DELEGATED  
APPROVAL  
11 JAN 2001

pp/0012670A

POTTER & HOLMES ARCHITECTS			
BASEMENT FLOOR PLAN AS EXISTING		6 PEMBRIDGE SQUARE FOR C.A.H.A.	
SCALE 1:100	DATE 18.9.00	DWG.No L04	REV A

SECOND FLOOR PLAN PROPOSED		6 PEMBRIDGE SQUARE FOR C.A.H.A			
		SCALE	DATE	DWG.No	REV
		1:100	18.9.00	L08

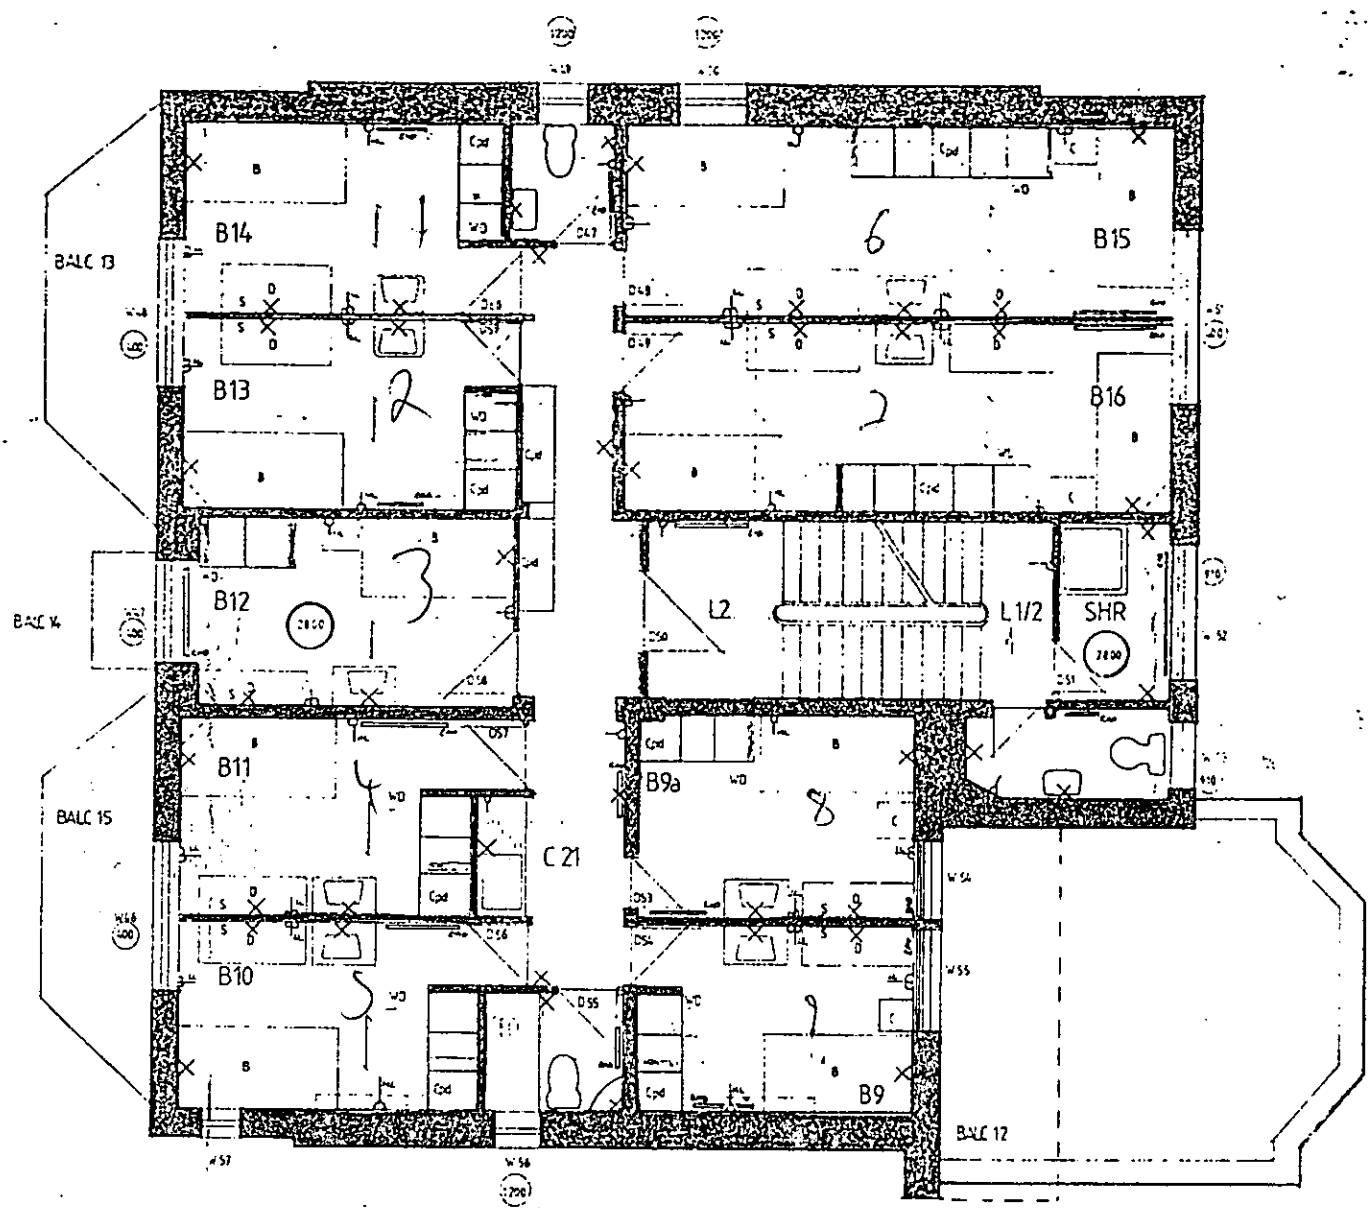
NO: DOORS ST 4 SW  
TO BE 600 MM WIDTH.

SECOND FLOOR PLAN EXISTING		6 PEMBRIDGE SQUARE FOR C.A.H:A	
SCALE 1:100	DATE 18.9.00	DWG.No. L09	REV

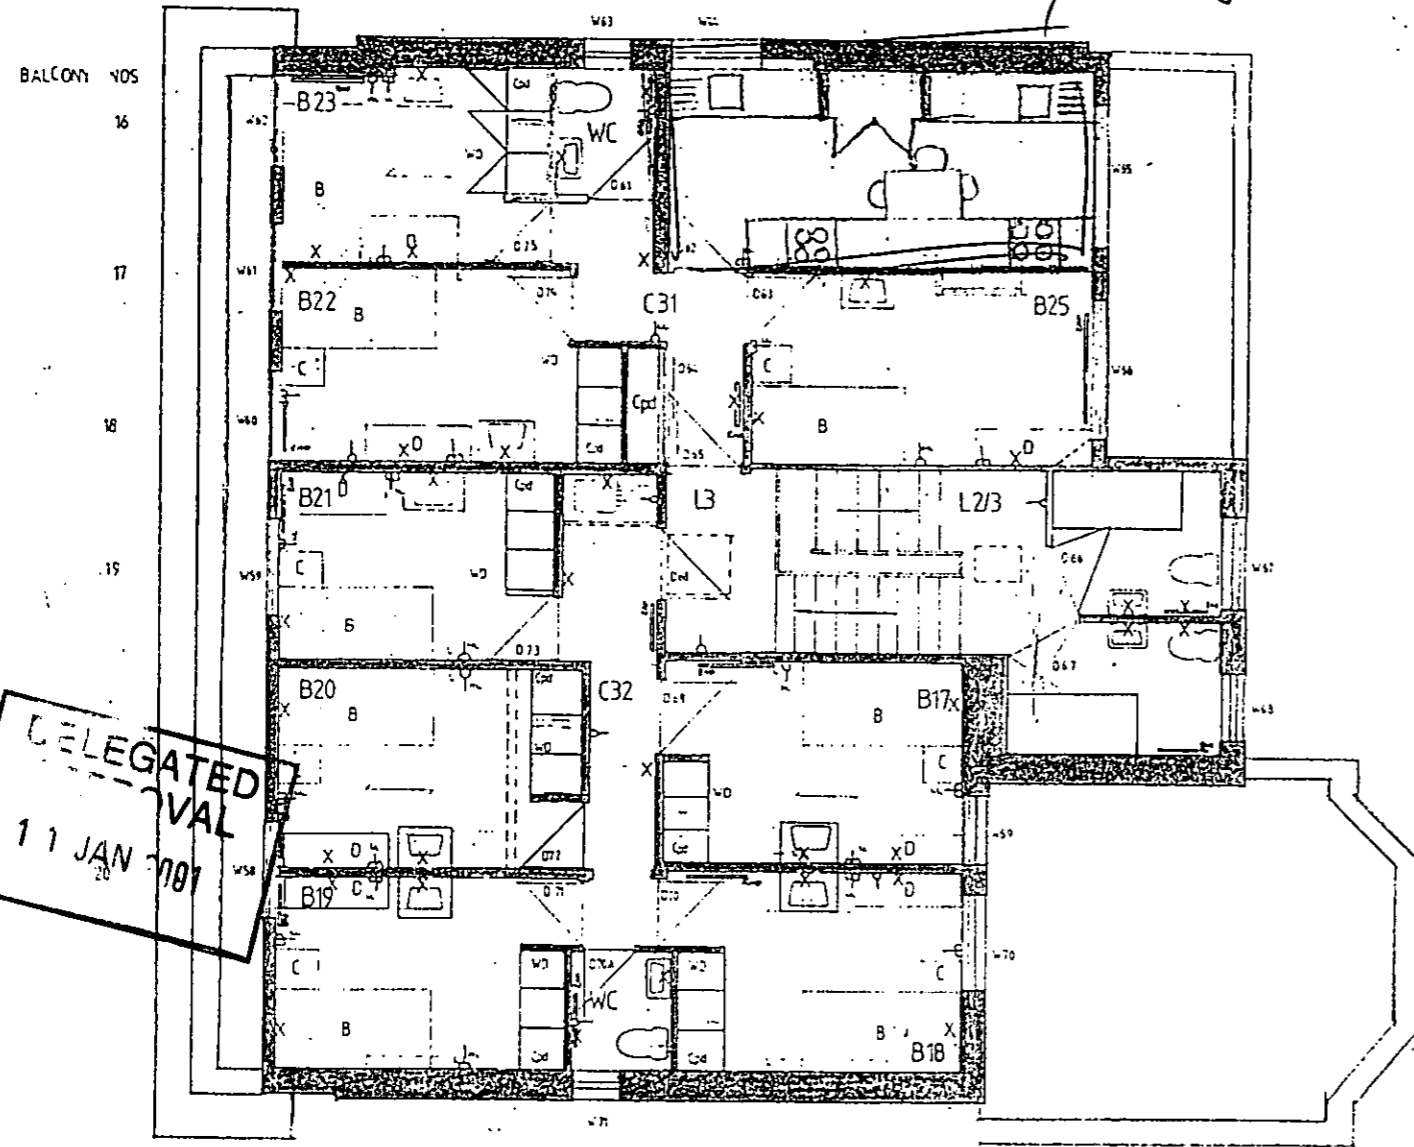
has of bed room?
